**APPLICATION FOR PERMISSION  
UNDER SECTION 16 OF  
THE TOWN PLANNING ORDINANCE  
(CAP.131)**

For Official Use Only 請勿填寫此欄	Application No. 申請編號	A77C-LFS/441
	Date Received 收到日期	~ 8 AUG 2022

**Proposed Temporary Warehouse for Storage of Building Materials for a Period of 3 Years**

**Lots 2072 (Part), 2075 (Part), 2081 (Part), 2082 (Part), 2083 (Part), 2084, 2085, 2086 & 2087 (Part) in D.D. 129 & Adjoining Government Land, Lau Fau Shan, Yuen Long, N.T.**

Figure 1

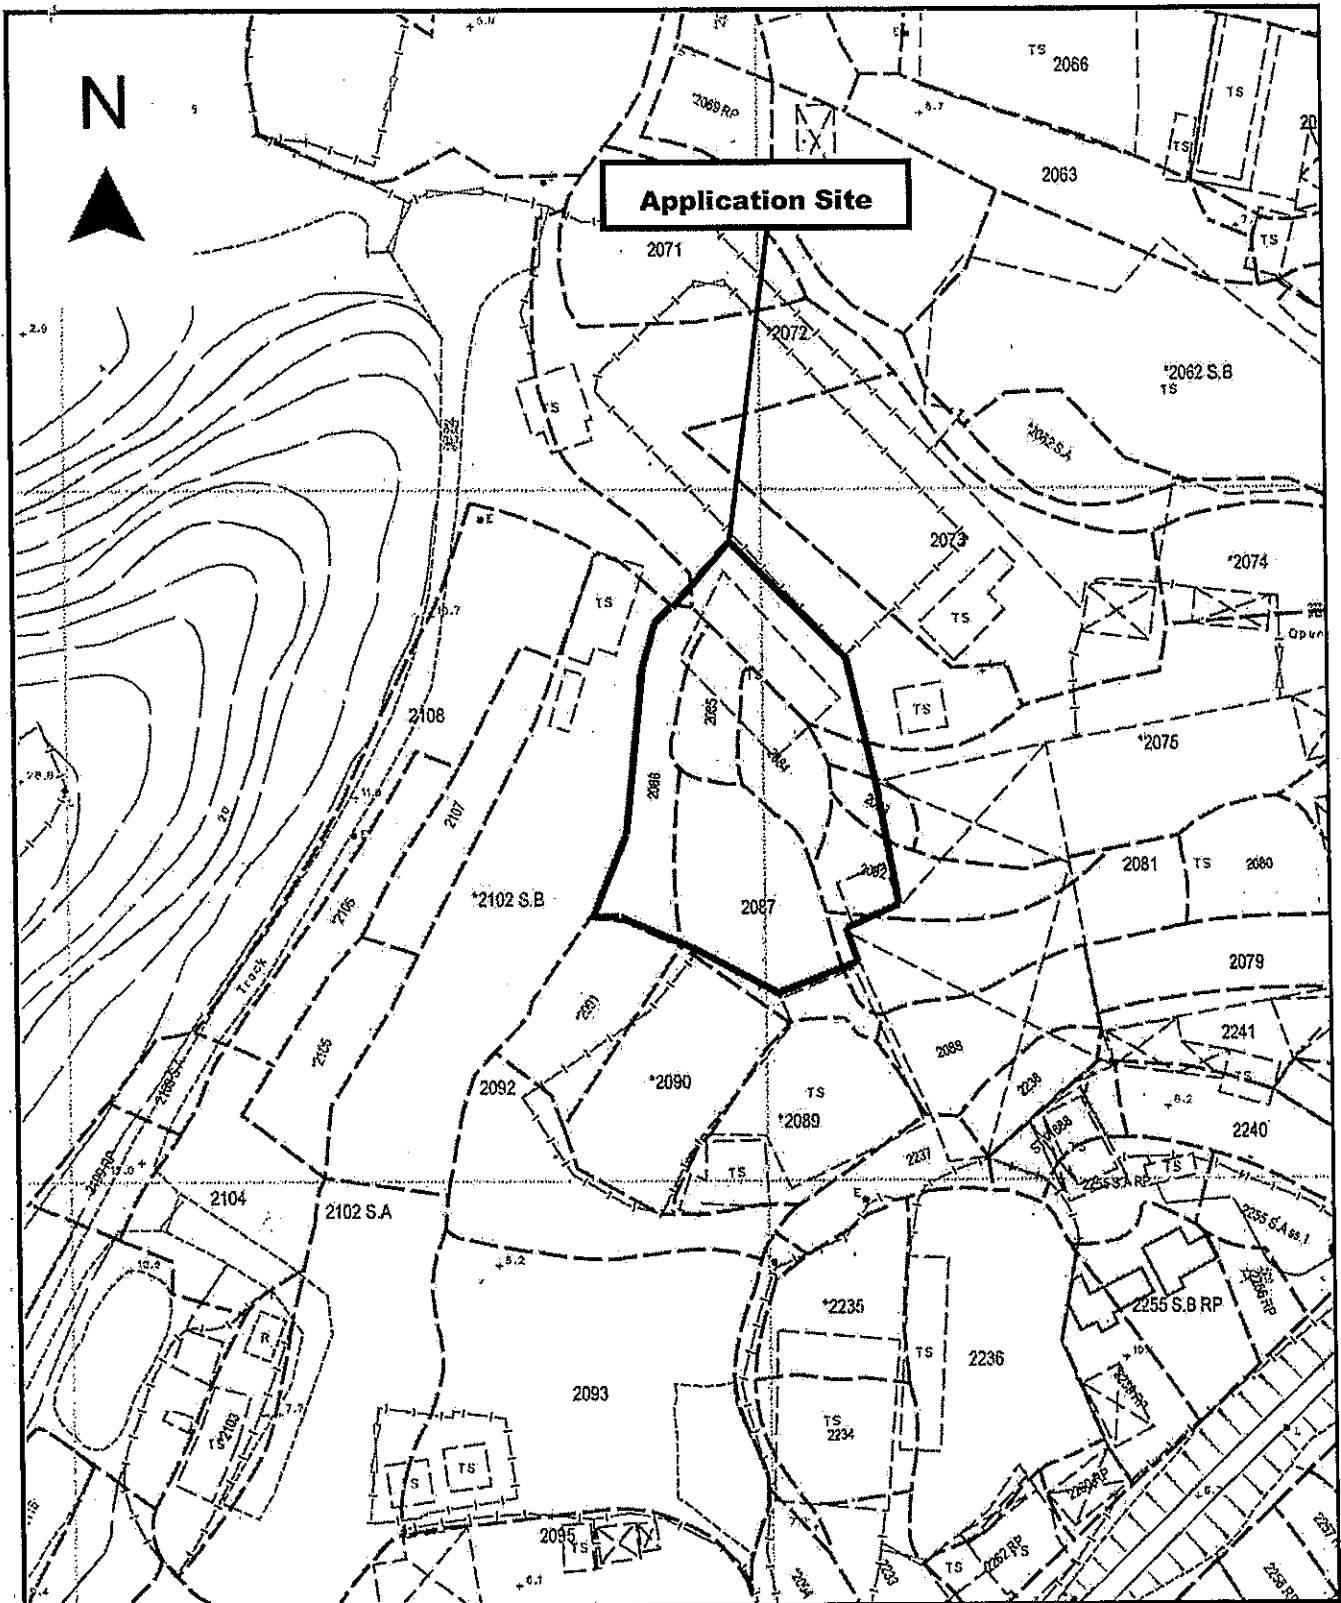
Transport Department's comments	Applicant's response
Please provide photos to show the building materials to be stored in the site, and clarify "directly linked with Yuen Long Highway via Lau Fau Shan Road" in para 2.4 of Annex 2.	Photos in the attachment show the building materials to be stored at the site.  The sentence should be read as "directly linked with Yuen Long Highway via Lau Fau Shan Road, Tin Wah Road, Tin Ying Road and Hung Tin Road" in para 2.4 of Annex 2.

The ingress/egress to Lot 2089 in D.D.129 as shown in Figure 1 is the only ingress/egress to the said lot. The applicant agrees the occupier of lot 2089 in D.D. 129 to pass through the application site to connect to the public road.

Figure 4

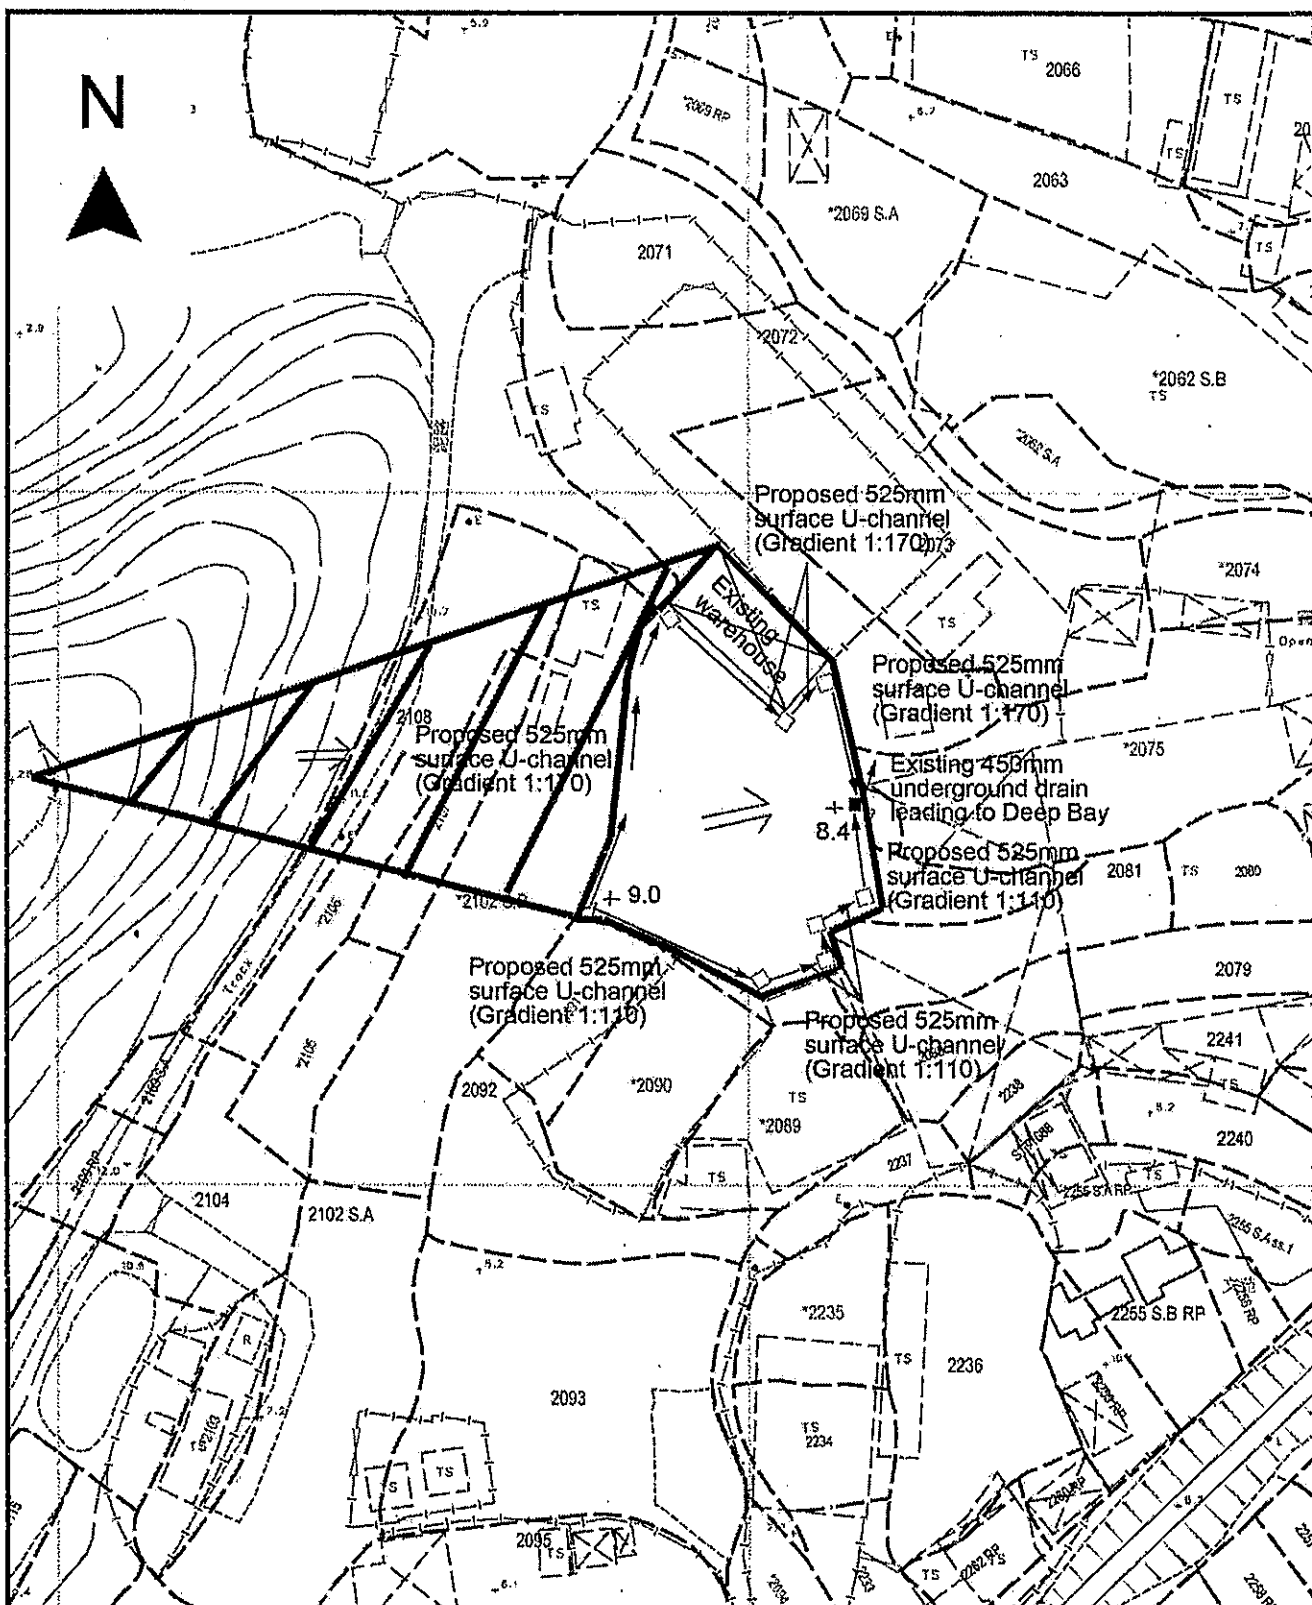
- (iv) further to (iii) above, since there is no record of the said discharge path, please provide site photos to demonstrate its presence and existing condition;

- (v) consideration should be given to provide grating for the surface channels;
  - (vi) the cover levels and invert levels of the proposed U-channels, catchpits/sand traps should be shown on the drainage plan;

- 1.2.1 Subject to the above calculations, it is determined that 525mm surface U-channel which is made of concrete along the site periphery is adequate to intercept storm water passing through and generated at the application site (Figure 4).

- 1.2.2 The collected surface runoff will be conveyed to existing 450mm diameter underground pipe at the eastern part of the site. (Figure 4)
- 1.2.3 All the proposed drainage facilities, including the section of surface channel proposed in between of the subject site to the open drain, will be provided and maintained at the applicant's own expense. Also, sand trap and U-channel will be cleaned at regular interval to avoid the accumulation of rubbish/debris which would affect the dissipation of storm water.
